47th Meeting Informal Group on Child Restraint Systems

Booster Vehicle Seat Fixture Development

14th October 2014
Farid Bendjellal

Vehicle	Attachment	Position	Issue	Comment
Audi A1	Belt	Outer	C-Pillar	Significance – Minor No angle change (1.5°) Amount to remove $\approx 5\text{mm}$

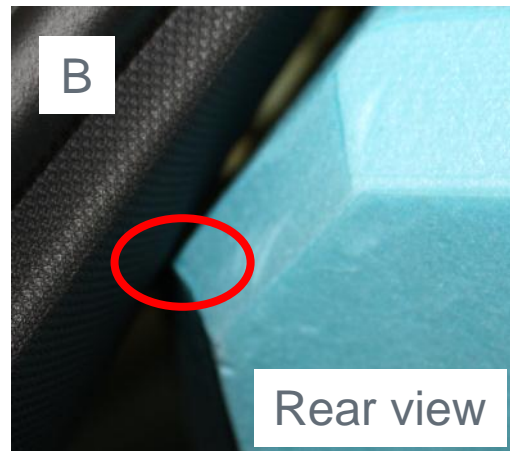
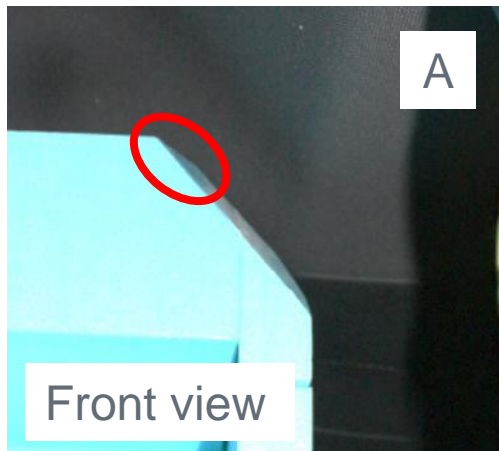
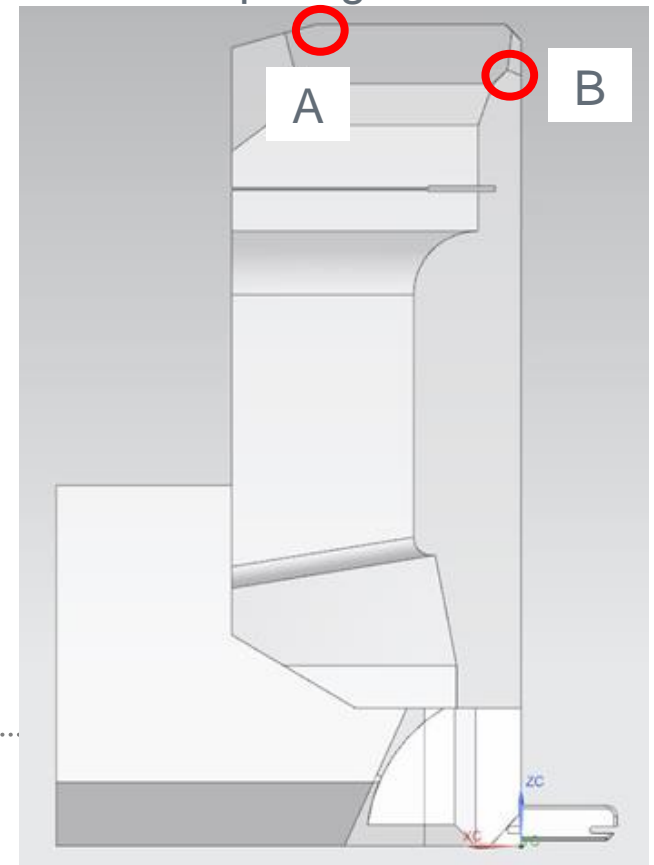
2 interactions with C-pillar / roof

Areas requiring modification

Vehicle	Attachment	Position	Issue	Comment
Mitsubishi Space Star / Mirage	ISO	Outer	C-Pillar	Significance – Minor No angle change (1°) Amount to remove \approx 5mm

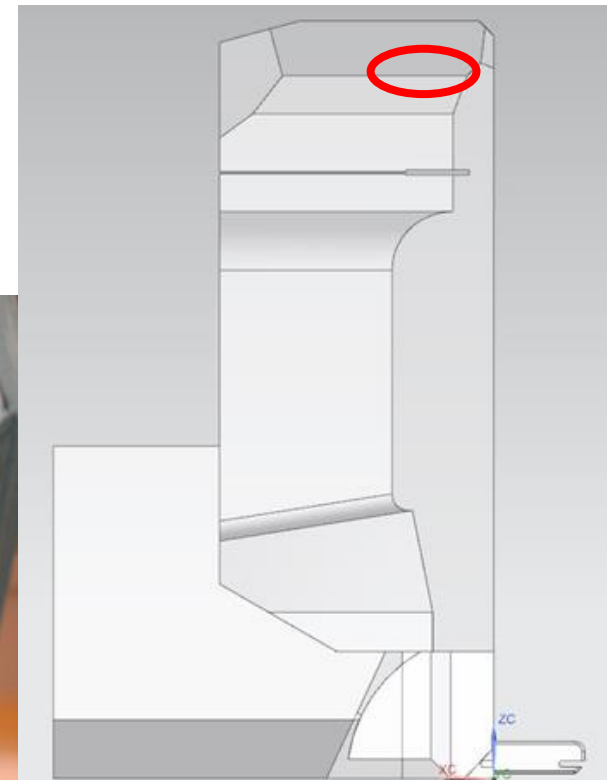
Straighten edge would
remove contact

Contact with C-Pillar
(ISOFIX only)

Area requiring modification

Vehicle	Attachment	Position	Issue	Comment
Vauxhall Adam	ISO	Outer	C-Pillar	No interaction Action – None

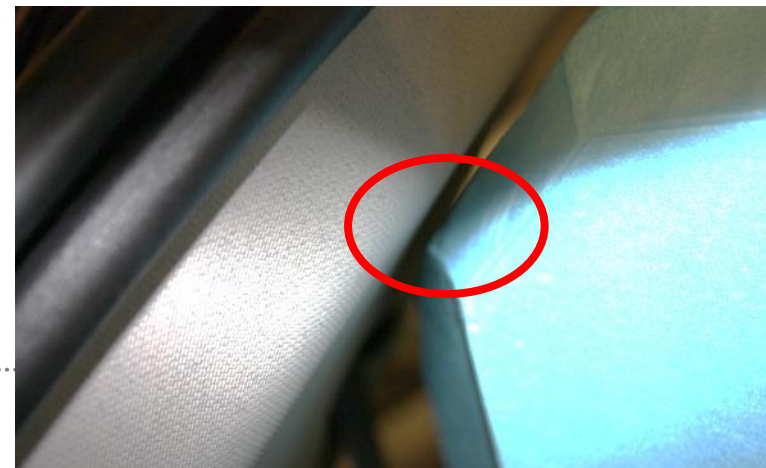
- No interaction found
- Gap between C-Pillar and fixture using ISOFIX
- Conclusion: Fixture fits

Vehicle	Attachment	Position	Issue	Comment
Vauxhall Zafira Tourer	Belt/ISO	Outer	Door	Significance – Minor No angle change (1°) Amount to remove $\approx 5\text{mm}$

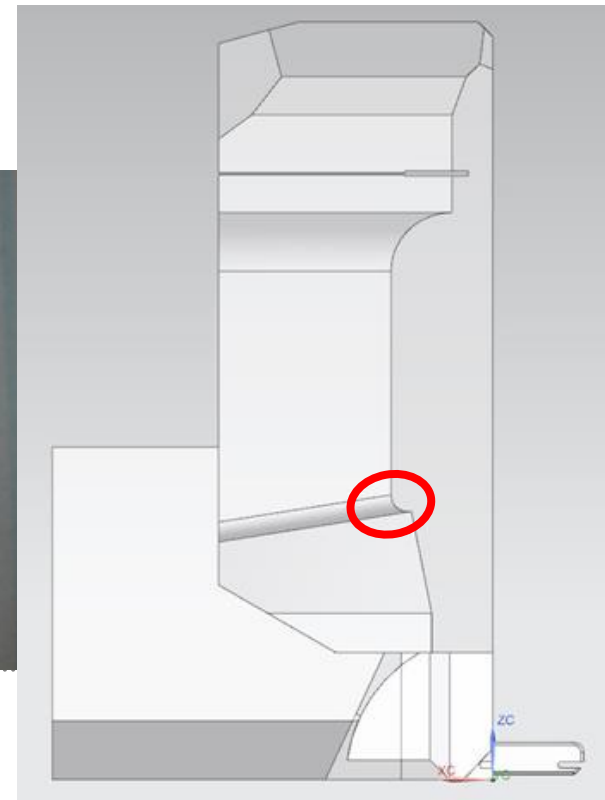
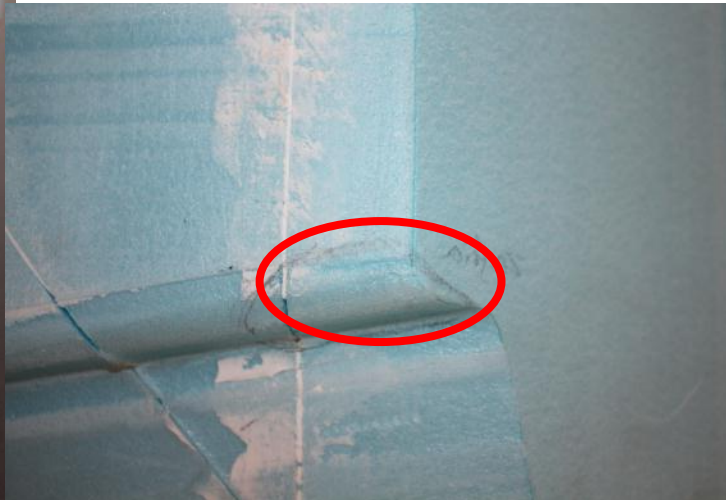
Very small contact with door

Area requiring modification

Remove material $\approx 5\text{mm}$

Summary of Modification Areas

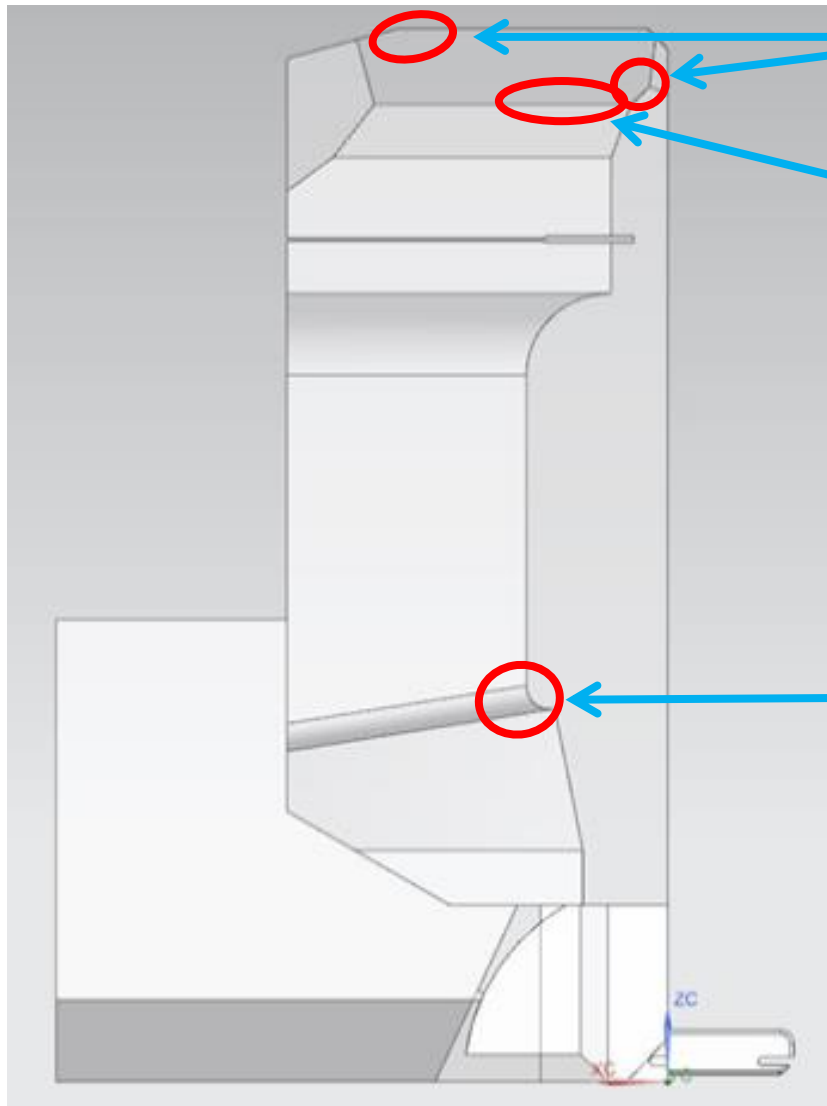
Proposed modification areas

A1 C-Pillar interaction

Space Star C-Pillar interaction

Zafira door interaction

A1 C-Pillar/roof interaction

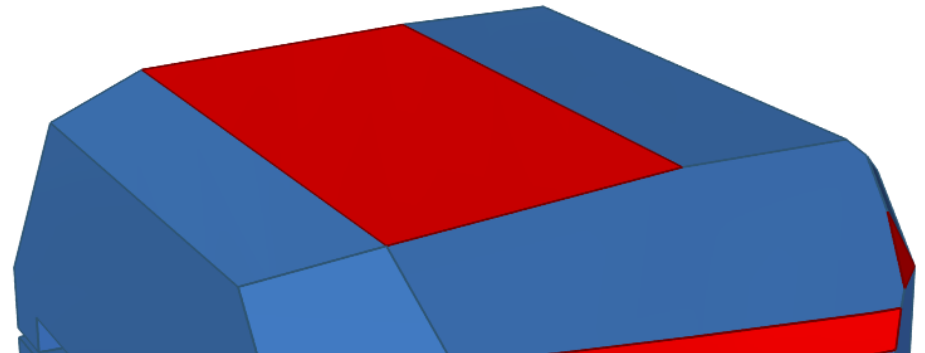
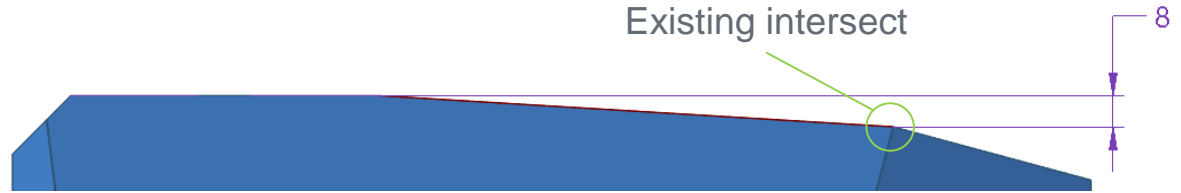
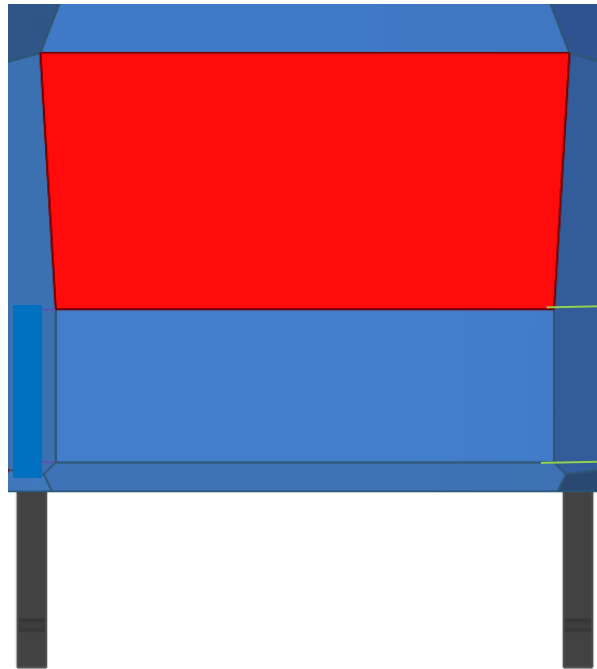
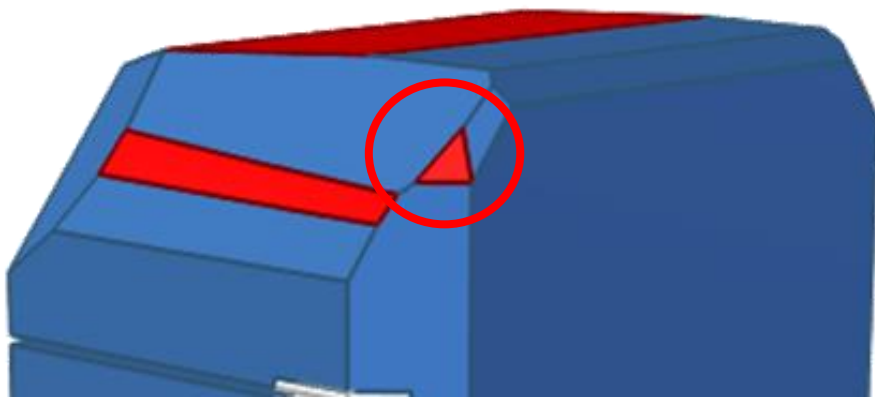
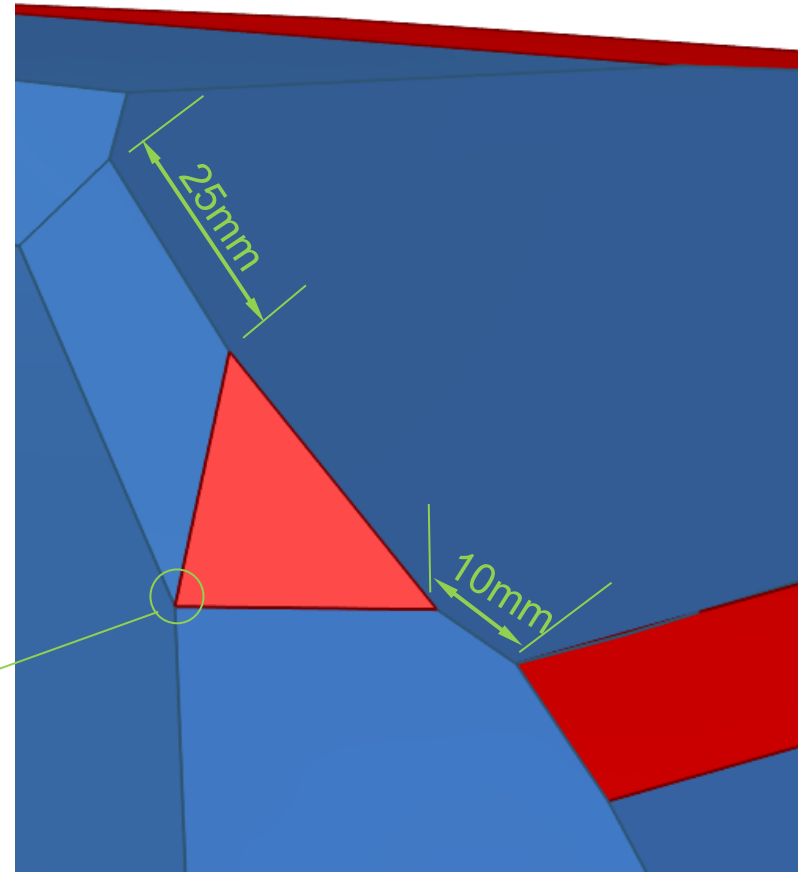
Existing intersect
